MEMORANDUM

SUBJECT: Broadlands Regional Medical Center - Response to Inquiry

This memorandum is to respond to the inquiry of the Planning Commission regarding the trip distribution assumed in the Traffic Impact Study (TIS) dated August 6, 2008, of the Broadlands Regional Medical Center (BRMC). The comment is shown in *italics* with the response in **bold** immediately following.

Figure 1 shows the travel patterns resulting from the shift in traffic away from the Greenway and onto the local road network. The result of the capacity analysis, along with a comparison to the results as presented in the TIS, is shown in Table 1.

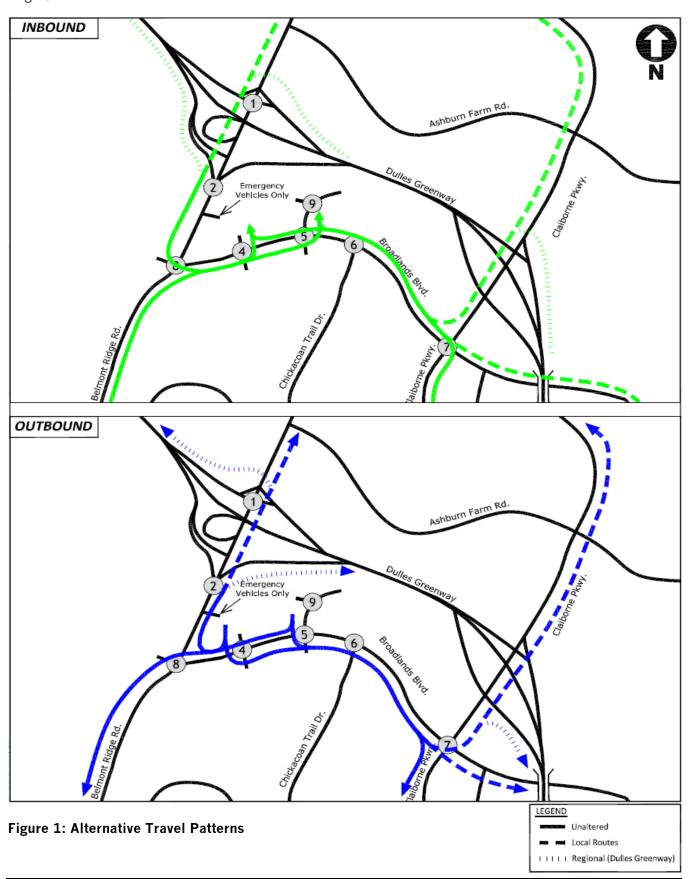
1) How would the road network operate if more trips for the BRMC were assumed to be distributed along the local roads rather than the Dulles Greenway?

The official traffic impact study assumed 60% of the traffic to and from the proposed site would utilize the Dulles Greenway (20% from the west, and 40% from the east), as agreed upon at the scoping meeting. This is because of the regional nature of the proposed hospital and because the market area the hospital will serve extends beyond the immediate Ashburn community.

In response to the Commission's question and at the request of the Office of Transportation Services, we tested the original assumption by reducing by one-half the amount of both hospital and on-site medical office traffic distributed on the Greenway (10% from the west and 20% from the east), with 30% redistributed on the local network. This test assumption was then compared to the results of the official traffic impact study to determine the peak hour incremental difference the revised assumptions would have on the road network.

The results shown in Table 1 are similar to the results of the TIS prepared for the site, showing there is sufficient capacity in the local network to accommodate the proposed development. Due to the change in distribution, the level of service (LOS) of the unsignalized southbound approach at the intersection of Broadlands Boulevard and Glebe View Drive/site entrance falls below the acceptable LOS 'D'. However, this intersection is proffered to be signalized if and when warranted, which would result in acceptable levels of service for all approaches.
